STATE OF MAINE
DEPARTMENT OF TRANSPORTATION
16 STATE HOUSE STATION
AUGUSTA, MAINE 04333-0016

October 18, 2021
Subject: Interstate 295/US Route 1
Northbound & Southbound Bridge
Replacements & Multiuse Path
State WINs: 023106.01 & 023825.00
Location: **Yarmouth**
Amendment No. 2

1-295 OVER US ROUTE 1
EXIT 17 INTERCHANGE
YARMOUTH CUMBERLAND
BEARING LAYOUT - SB

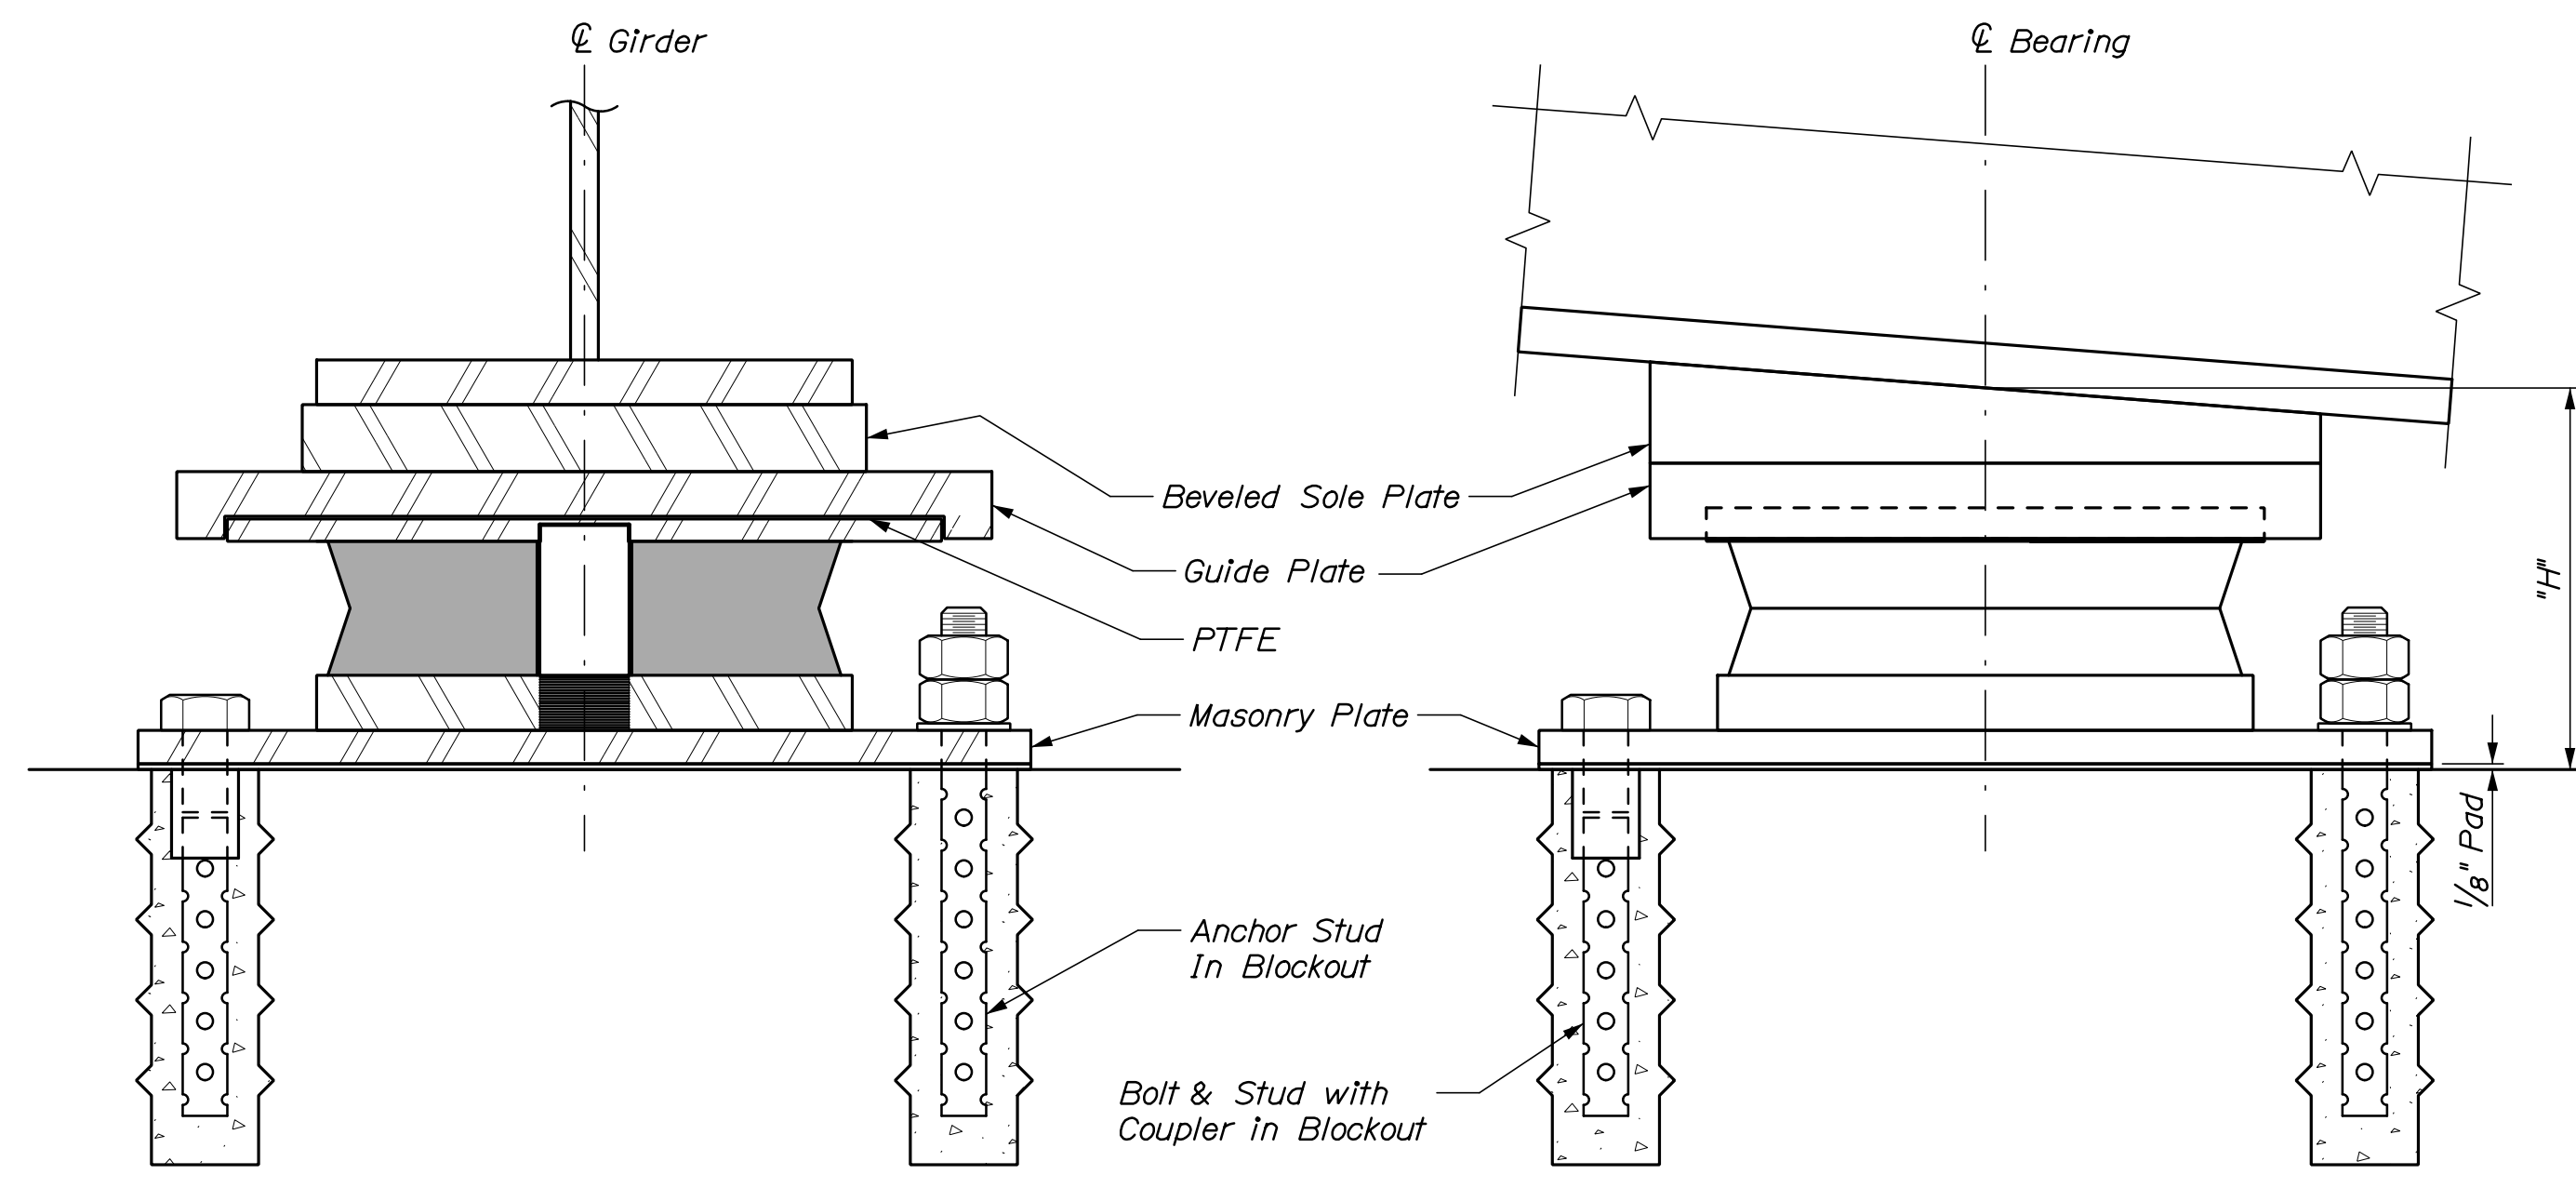
Question: Disc bearings: the horizontal loads at the Fixed Abutments for both bridges are exceedingly extreme (150% to 250%) as compared to the vertical loads at these locations. We have never seen such extreme condition before and question if this is an error or if not “if the EOR has determined that this extreme HL will NOT cause uplift, overturn or other problems with these bearings.

Question: The NB and SB bridges have significantly different design rotations. Can you please confirm the design rotations stated for the Bridges?

Response: Please see changes to the plan set.

Response: Please see changes to the plan set.

I-295 OVER US ROUTE 1
 EXIT 17 INTERCHANGE
 CUMBERLAND
 YARMOUTH
 BEARING DETAILS - SB

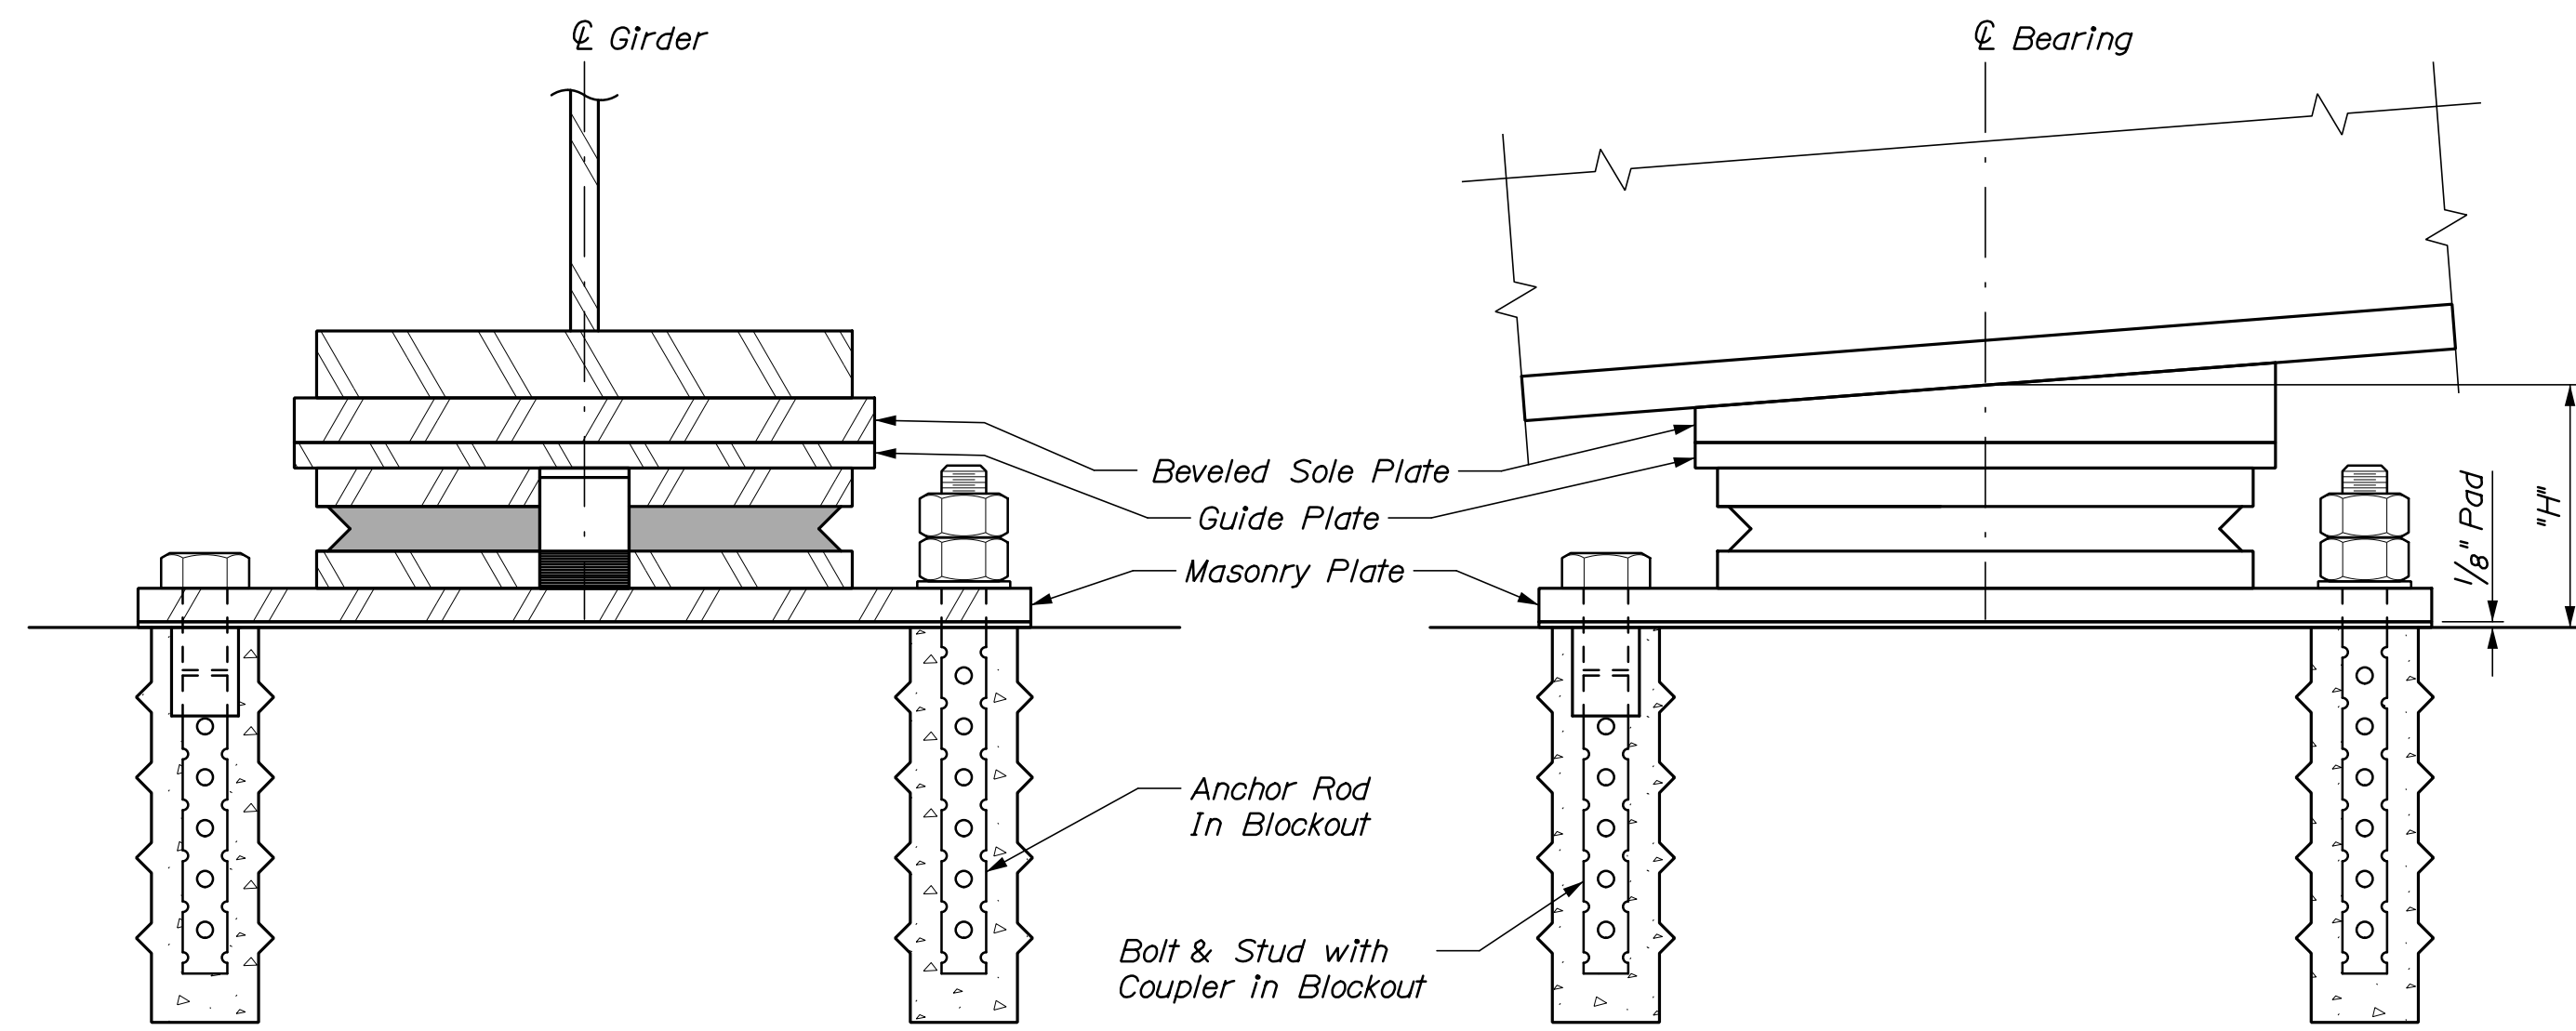
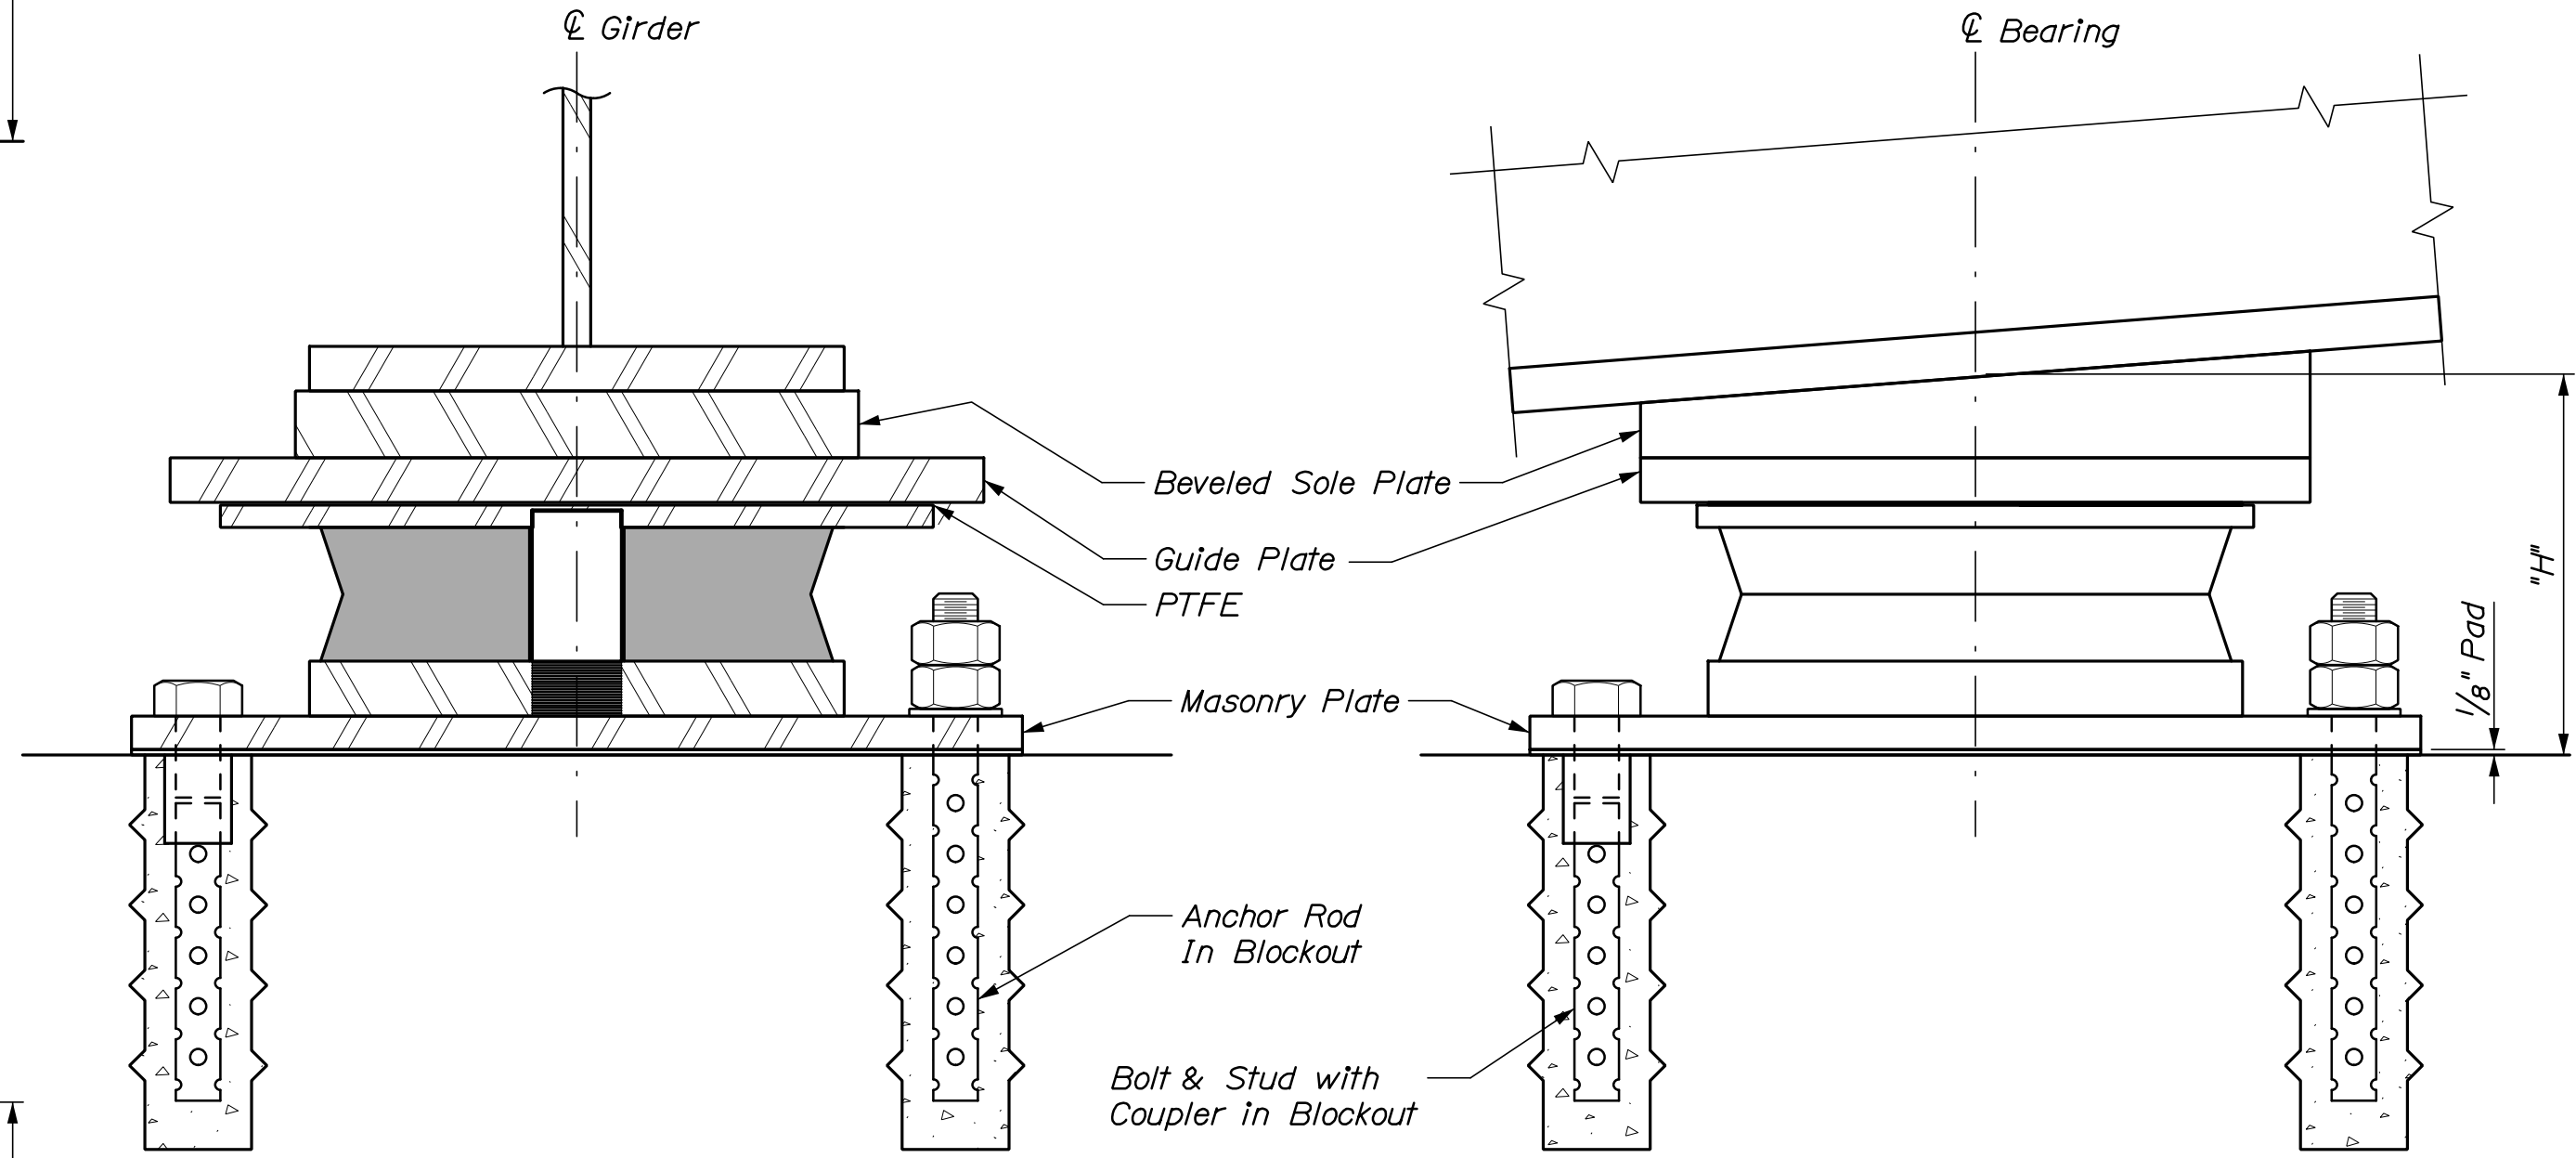
Question: The Disc Bearings for Bridge 1509 – Abutment No. 1 and Bridge 5833 – Abutment No. 2 have Service Horizontal Loads (HL) GREATER THAN the Service Vertical Loads (VL) - as much as 185% HL vs. VL. This is contrary to AASHTO recommendation and requirements for HLMR bearings. No such loading combinations has ever been attempted to our knowledge and it is doubtful that a disc bearing will work properly or withstand this type of loading conditions without some kind of damage. No type of testing of loading conditions such as these is even possible since the bearing would be forced out of the test press due to the much higher horizontal load.

If this loading condition is indeed present, some type of Shear Key (or similar structure) should be designed by the EOR to accommodate the huge HL and it should not be left for the disc bearing to bear the complete excessive HL. Please have the EOR review this and send a reply as soon as possible since a change in design may be required for the structure.

Question: Please see Disc Bearing Design Tables located on sheets 238 of 312, and 277 of 312. The horizontal loads shown for the fixed and transverse expansion bearings are greater than their vertical loads. Horizontal loads this great are not ordinary. Please confirm that the horizontal loads shown in the Disc Bearing Design Tables are correct.

Response: Please see changes to the plan set.
